Martin Place OSD DRP – Session 07 18.12.18:

Martin Place Metro

DRP - 8

METRO MARTIN PLACE | SOUTH TOWER

North Tower OSD Through Site Connection Plan and Section with key dimensions

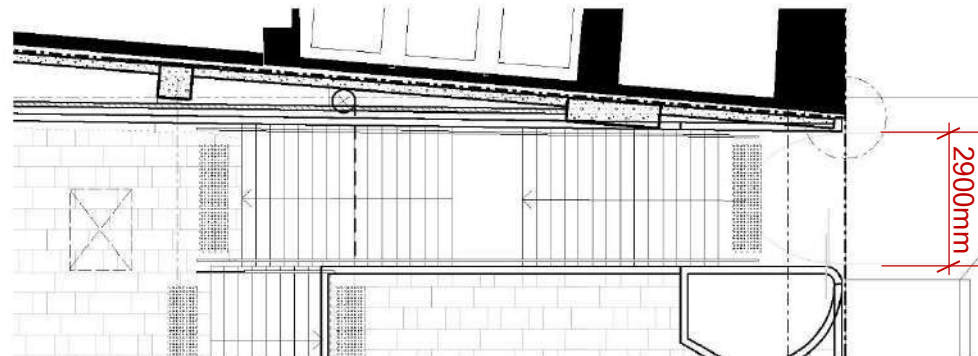
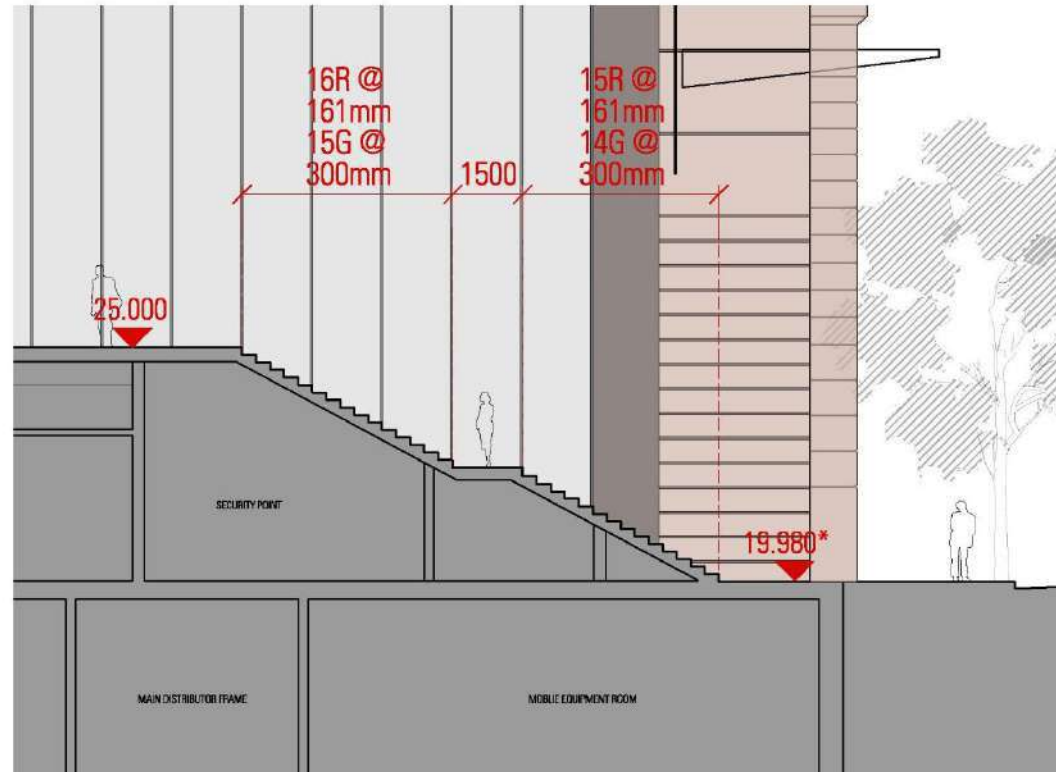
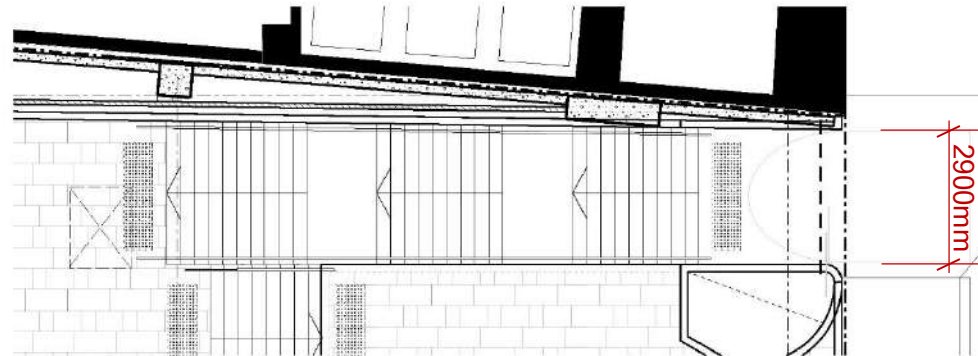
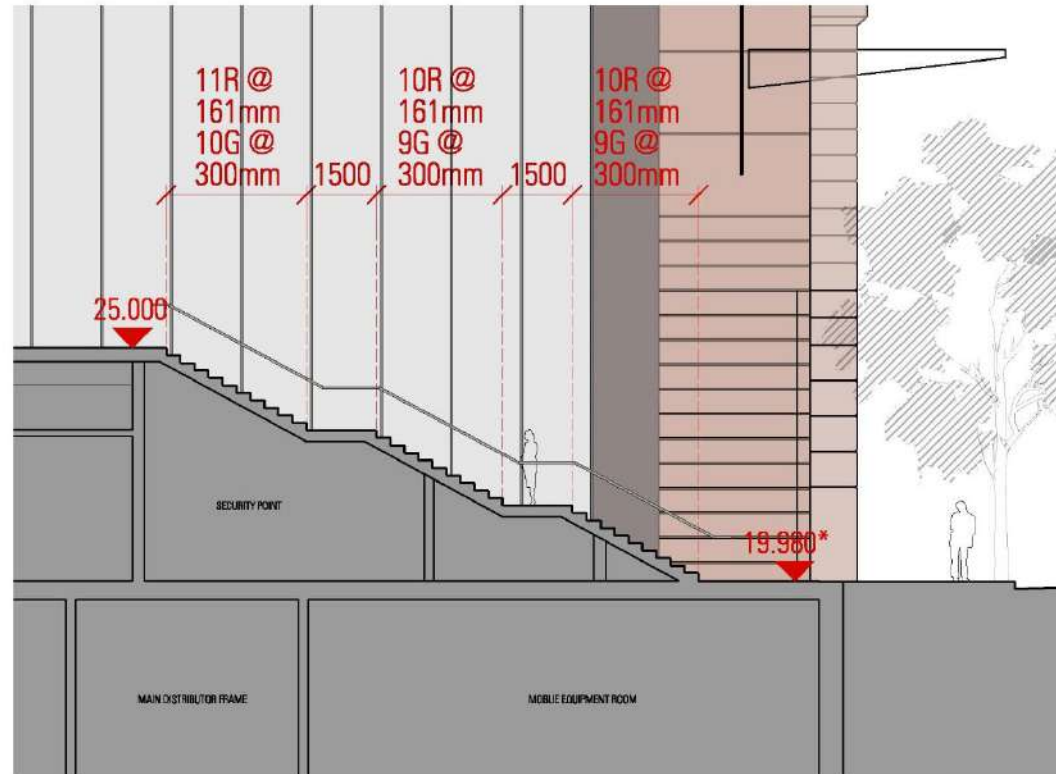
DRP comment *a more decisive approach is required to provide a fully open and publicly accessible space. It is crucially important that if this is to be a public room, that details and materials reflect this approach, and that any commercial signage or branding doesn't detract from the public nature and feel of this space*

- *Exploration of extension of masonry elements from outside to in to reflect public character of the through-site link*
- *Legibility, accessibility and public character of the through site link is not yet adequately resolved*
- *Further information relating to the intended character and operation of the space which should emphasise public connections*
- *Access to the through site link still seems overly constricted from Castlereagh Street – we strongly recommend further consideration be given to reducing the steepness of the stairway from Castlereagh Street*
- *Clear wayfinding logic to support the legibility of vertical and horizontal circulation between the through site link and the Hunter Street entrance and the levels above and below.*

Heritage Artworks

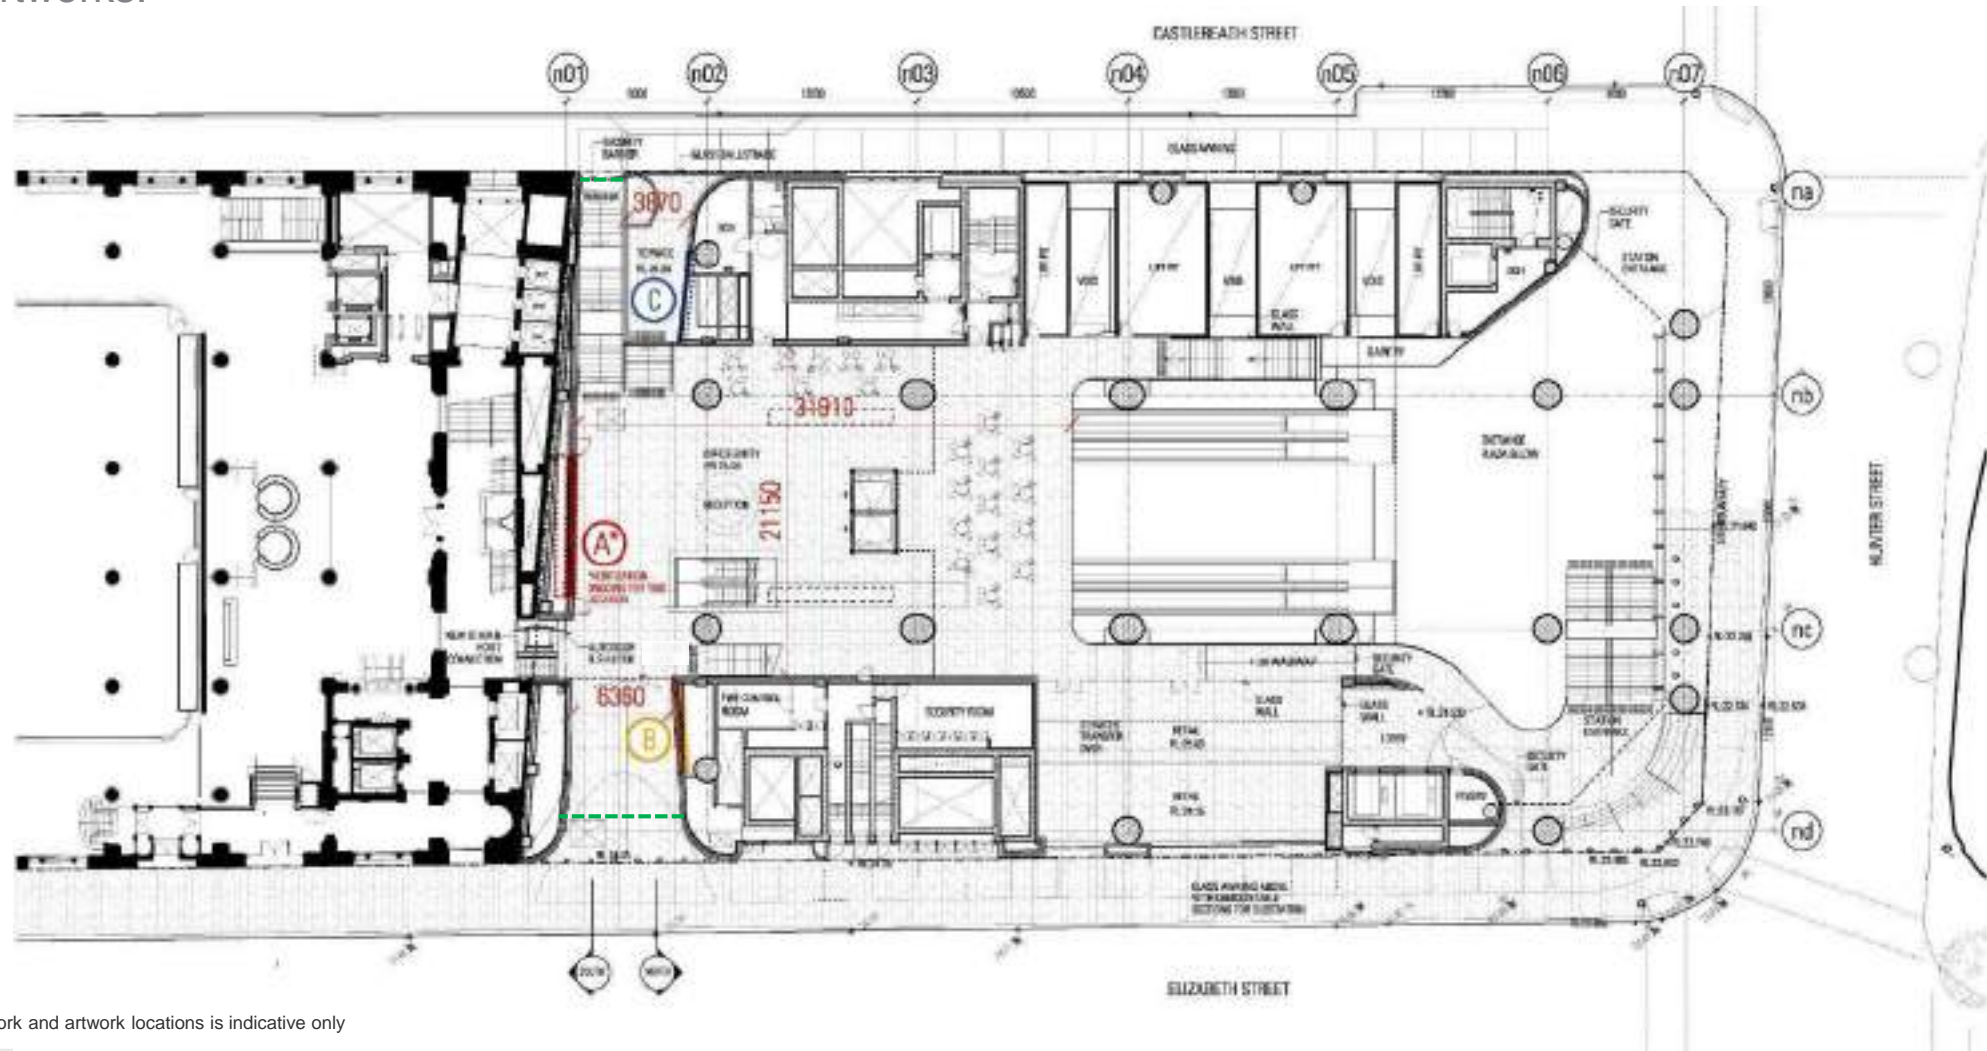
DRP comment *we support the locations of the artworks, careful consideration should be given to the base materials in which they sit (or are mounted), particularly the Tom Bass fountain which we believe is unsuited to an anodised aluminium surround, and similarly the Douglas Annand bronze sculpture. We are also concerned about the proposed mounting height of both these artworks, noting that the sculpture was originally mounted at a height of approximately 3 metres above an entrance doorway.*

We note the need for gates to secure the through-site link after hours, however these must not conflict with the reinstated artworks

- *Exploration of materials that are compatible with the calibre of the reinstated artworks*
- *Exploration of the height of the Tom Bass fountain and Douglas Annand bronze sculpture to reflect historic placement and enhance viewer experience*
- *Confirmation that the security gate off Elizabeth Street is located at the innermost end of the entrance*

Macquarie and Lendlease are continuing to refine the location and engineering considerations of reinstating the three heritage artworks.
